Intel[®] StrongARM[®] SA-110 Microprocessor Spurious Reset

Application Note

December 1999

Figure 1. Delay Circuit Implementation for the SA-110 and 21285

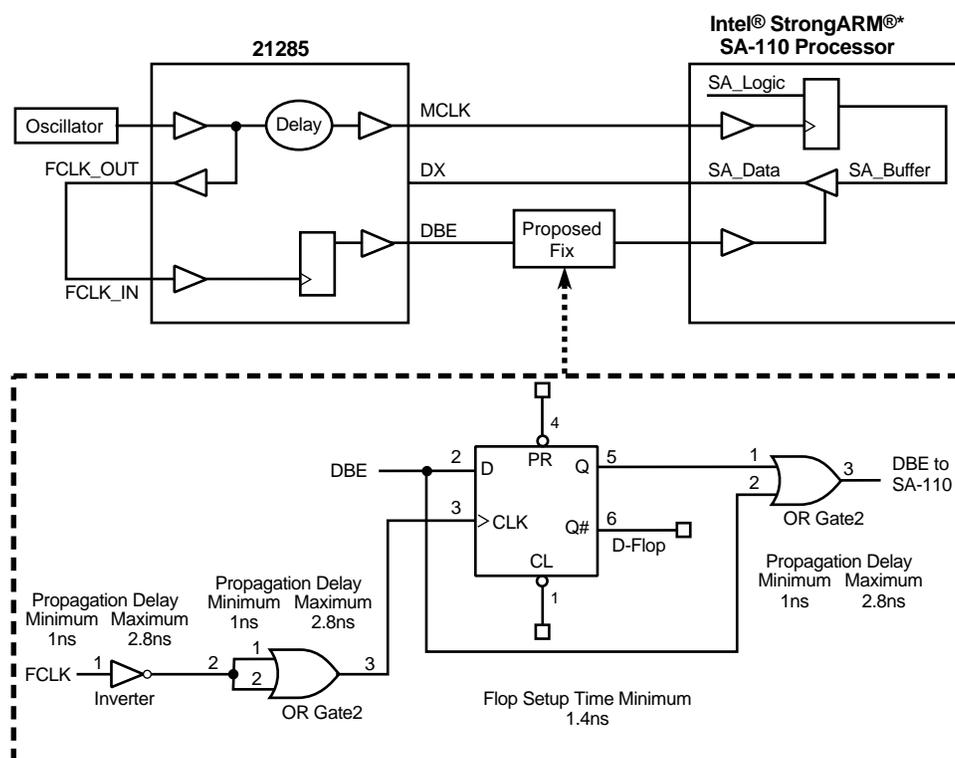
The SA-110 can encounter a spurious reset when deasserting DBE while all 32 data lines are switching high. The SA-110 susceptibility to reset under these conditions greatly diminishes as the number of switching data lines decreases.

The spurious reset condition occurs as follows. When the DBE signal deasserts, the SA-110 drives data to the output buffer through a flop clocked by MCLK and onto the data lines from a low to high state. The SA-110 output driver tristates while the data lines are at transition level resulting in a sufficient amount of system noise to cause the SA-110 to reset (fail). This condition can be avoided when the DBE signal is delayed properly.

It is recommended that the DBE delay deassertion must be moved beyond the critical data bus switching point, but it should not delay this deassertion into the next MCLK cycle. The recommended delay circuit is intended to function at all bus speeds.

1. An inverter to invert the FCLK signal.
2. A D-flop (clocking FCLK) and delay the DBE deassertion.
3. An OR gate to minimize the impact on the DBE signal deassertion.

Figure 1 shows a proposed fix for the noise sensitivity between the 21285 and SA-110 system implementation.

The inverter and buffer (an OR gate can be substituted) provides the inverted function and also delays the FCLK timing for a period between 2.5 ns to 5.6 ns (this includes some wire delay). Therefore, the requirement for DBE deassertion is no later than 8.0 ns (10 ns - 2.0 ns) with respect to FCLK. Table 4 lists the FCLK timing.

The requirement for DBE deassertion, listed in Table 5, is not later than 10.0 ns - 2.0 ns = 8.0 ns with respect to FCLK. These values are within the safe operating area.
